Airport Road Improvements

Municipal Class Environmental
Assessment
Airport Road
from 1.0km north of Mayfield Road to
0.6km north of King Street

B --- **STUDY COMMENTS RECEIVED AND STAKEHOLDER ENGAGEMENT**

**AIRPORT ROAD IMPROVEMENT
PROPERTY IMPACT PLAN
12451 AIRPORT ROAD
(PIN 143480013)**

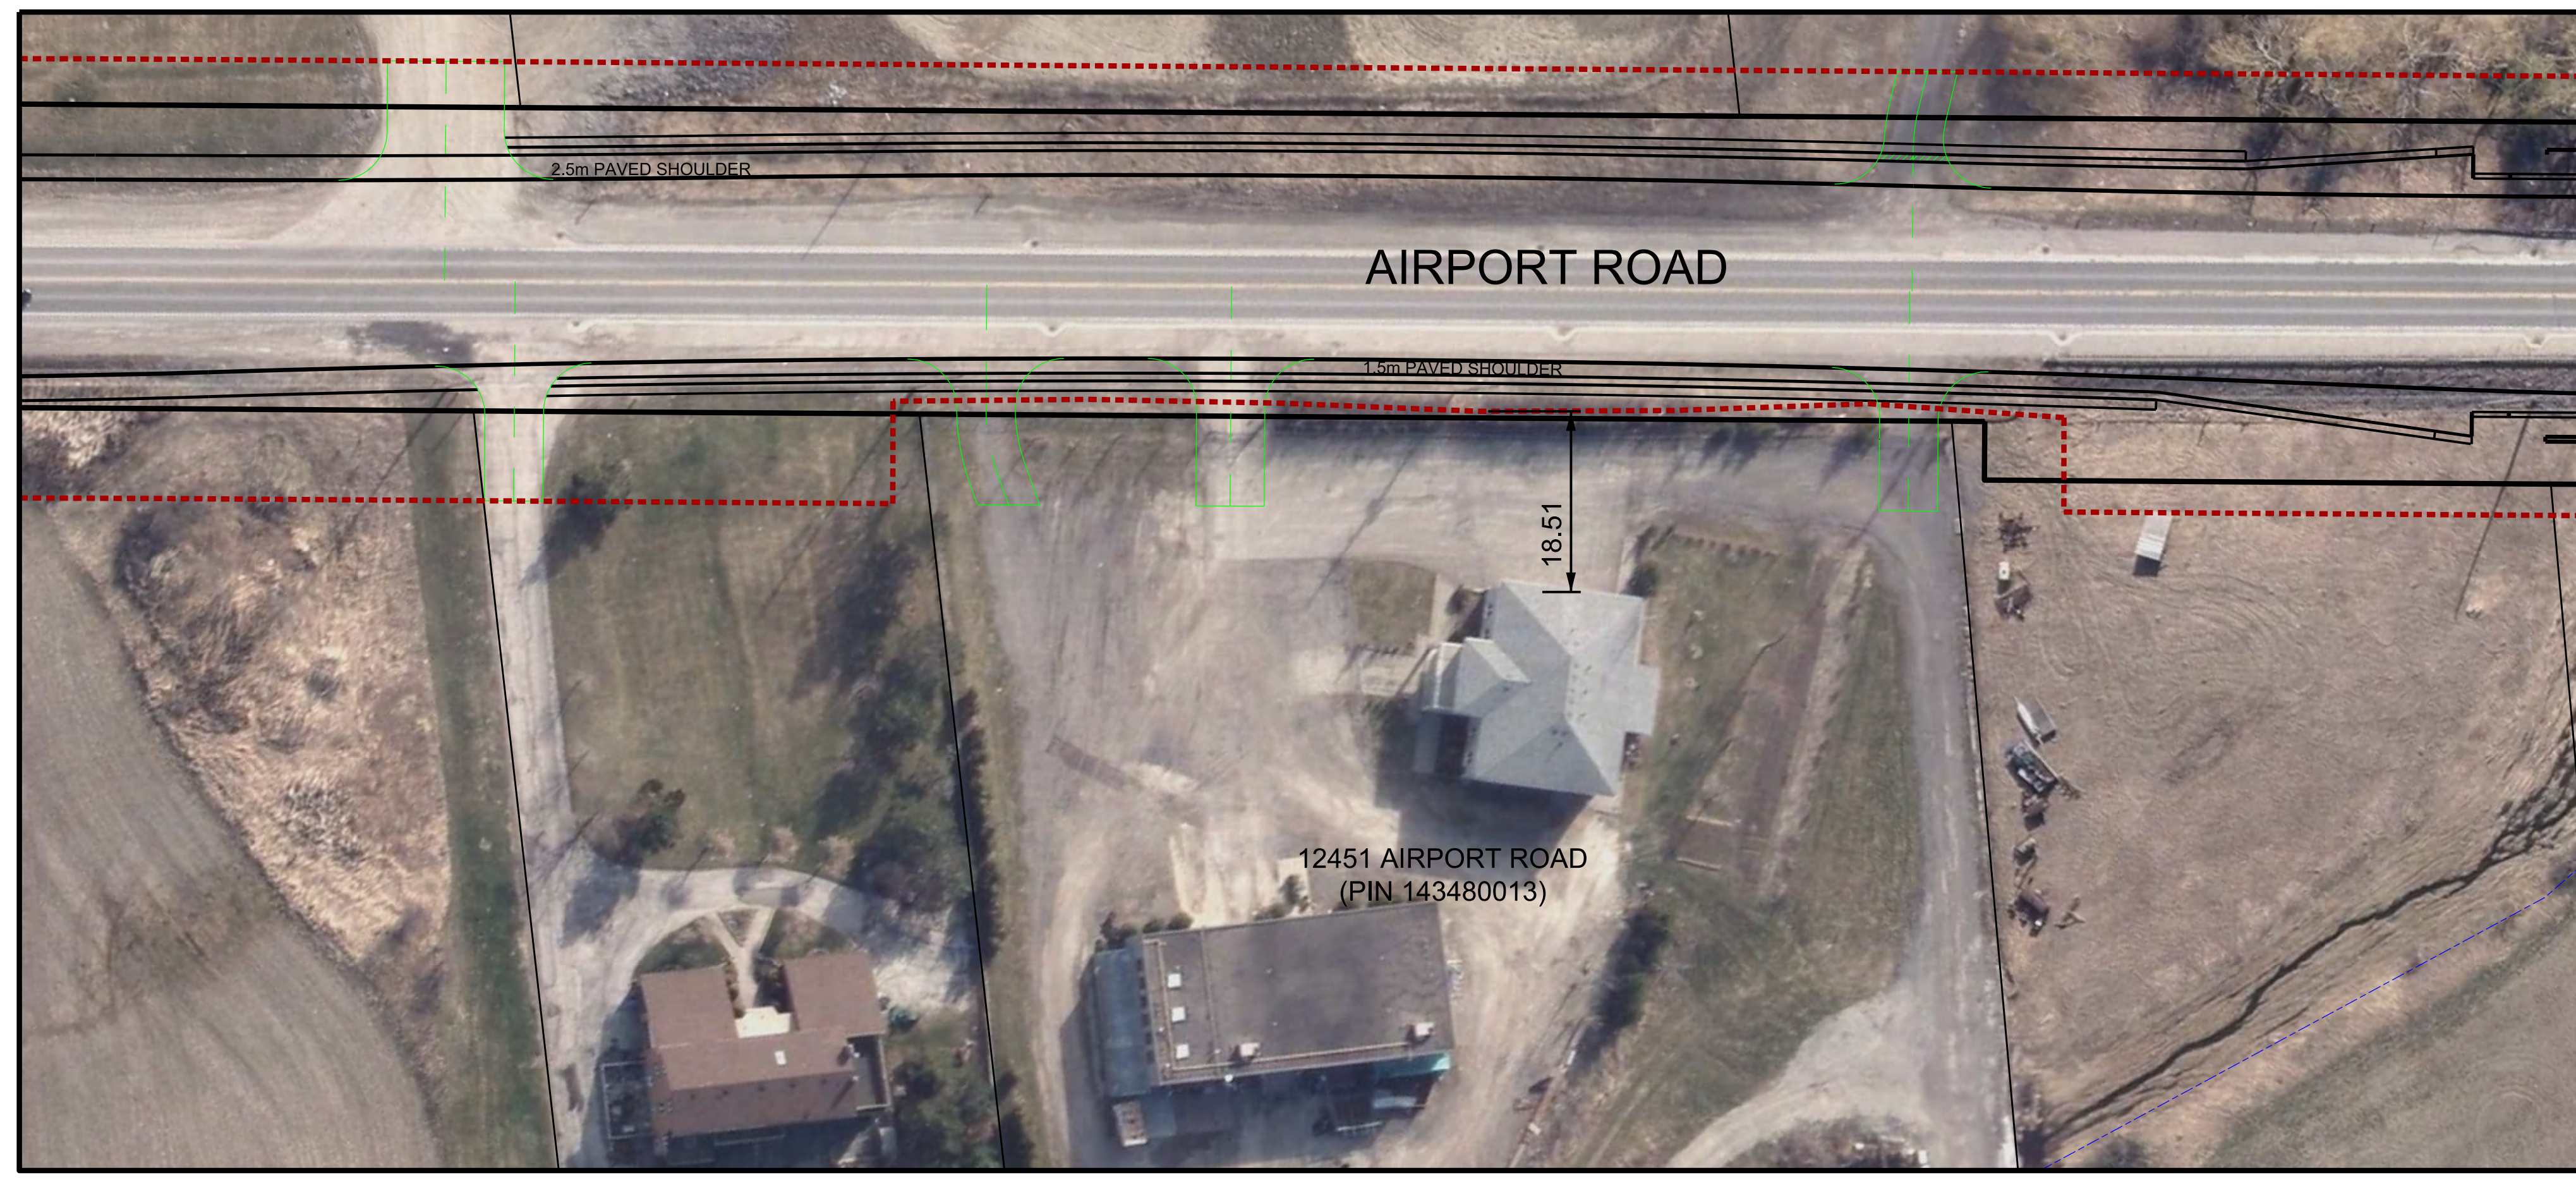
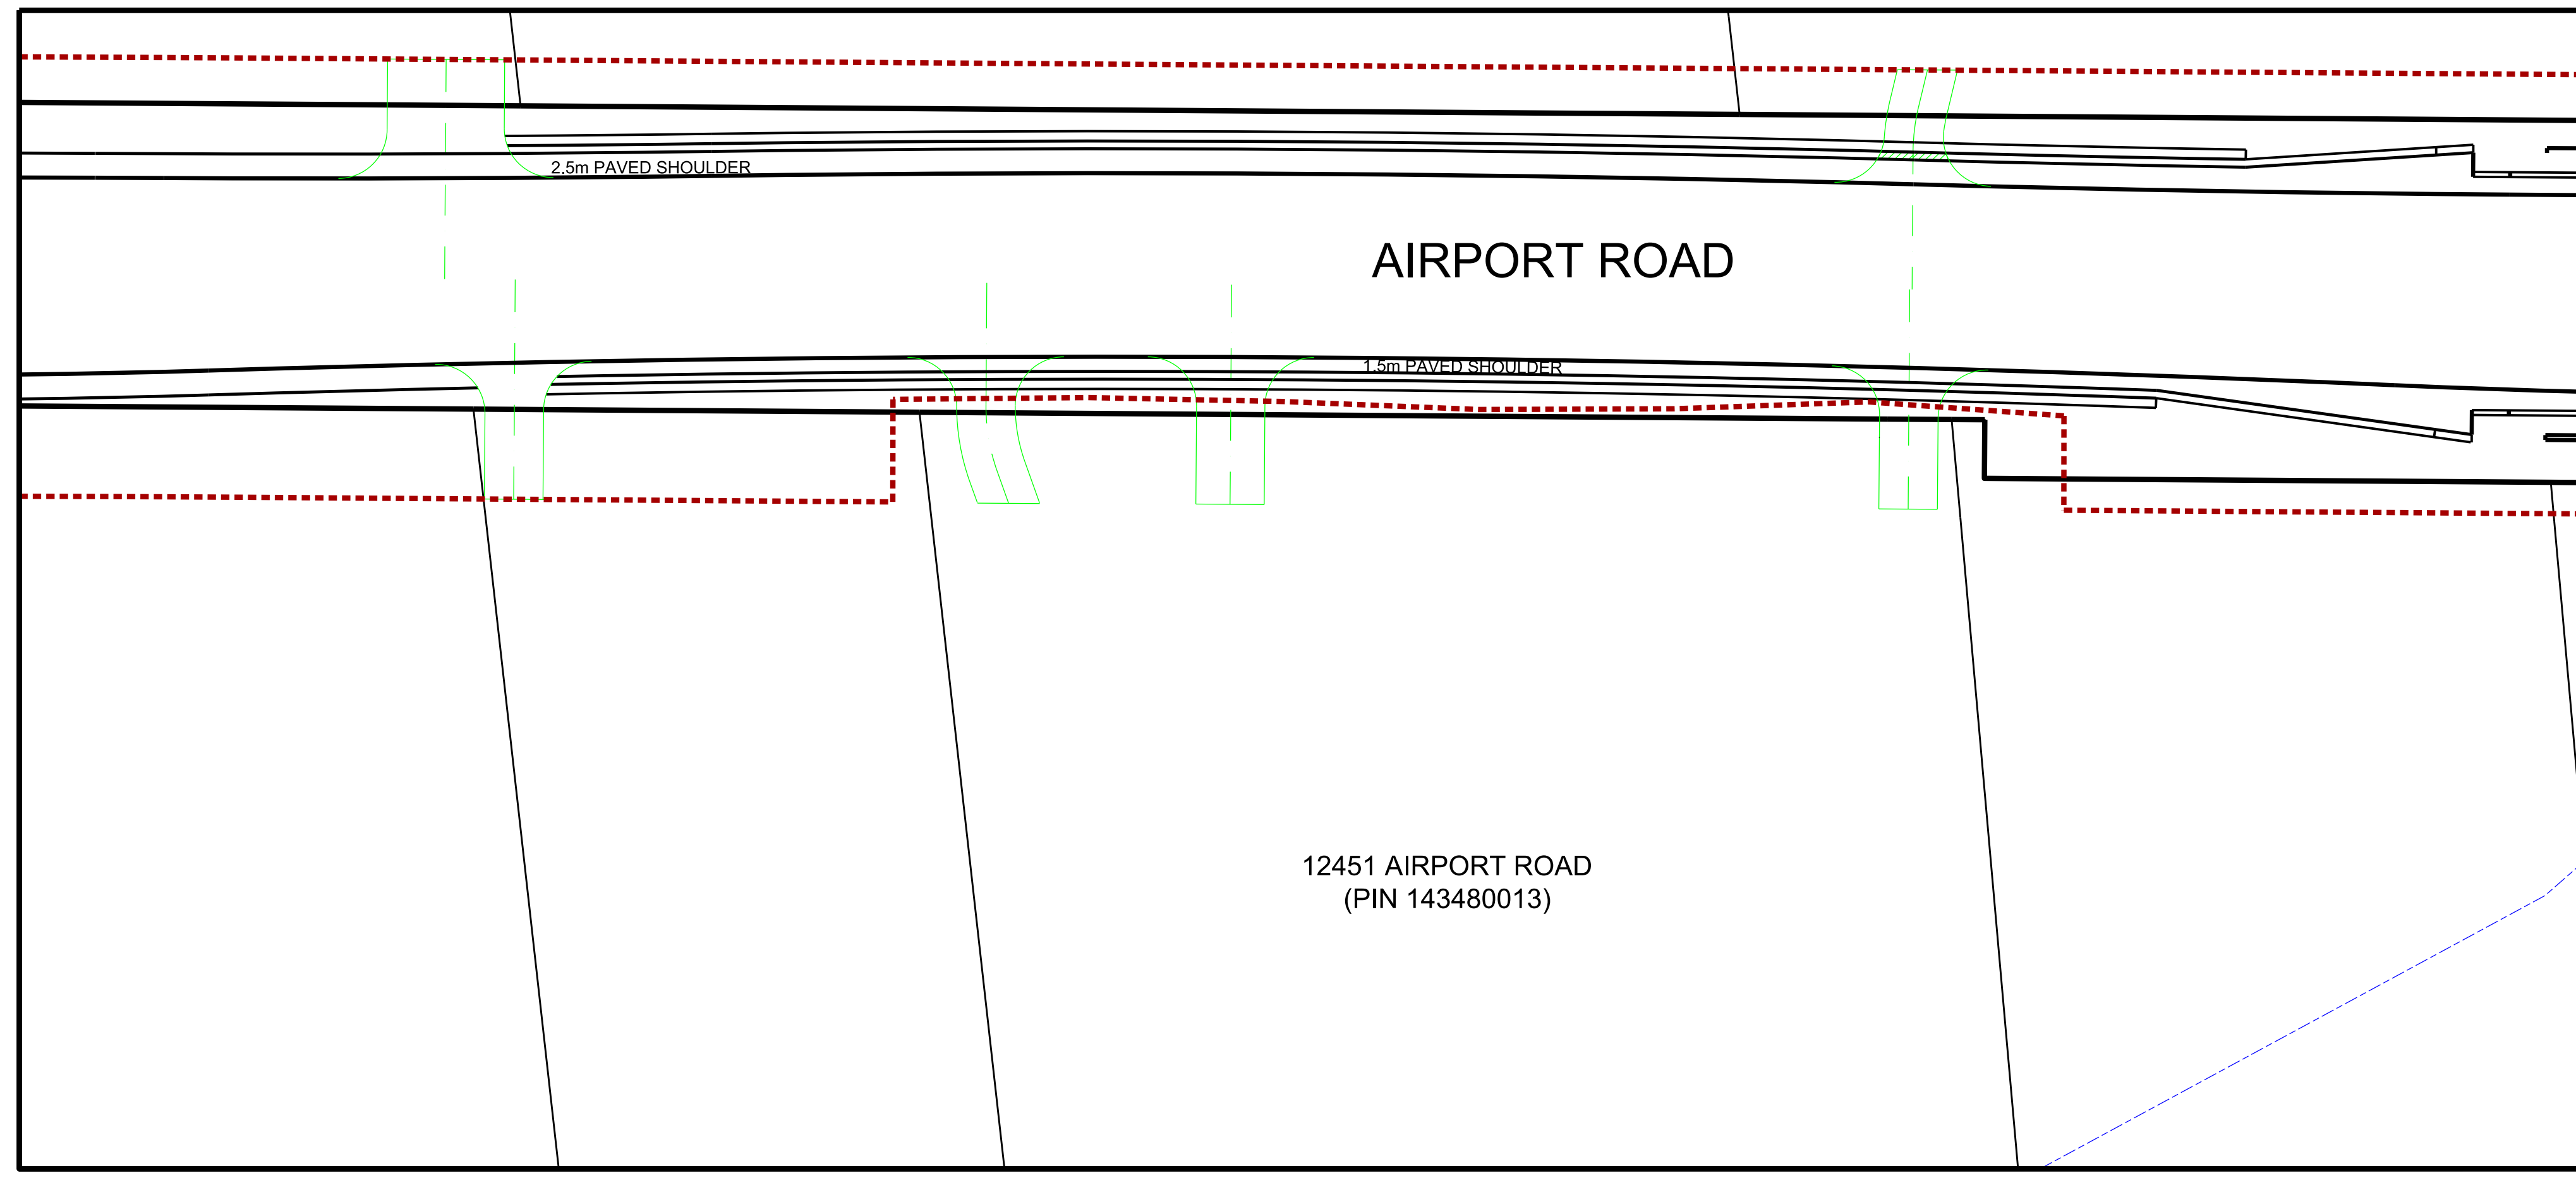
Mr. Testani was happy with the revision to our design that avoids a property requirement at his property. The attached show the updated PIP and a summary of what compromises where made. The roll plan and design plates from IBI already included in the ESR have the original PIP... This should all be documented.

- SHIFTED C/L 1.25m
- NO IMPACT TO STRUCTURE CROSS SECTION
- NO PROPERTY IMPACT
- FOLLOW GRADING LIMIT ROW, NOT 45m OP ROW

- 1:1 SLOPE WITH ENVIROLOK
- NO IMPACT TO LANDSCAPING
- CENTRE MEDIAN REDUCED FROM 5.5m TO 4.0m
- PAVED SHOULDER ON EAST SIDE REDUCED FROM 2.5m TO 1.5m
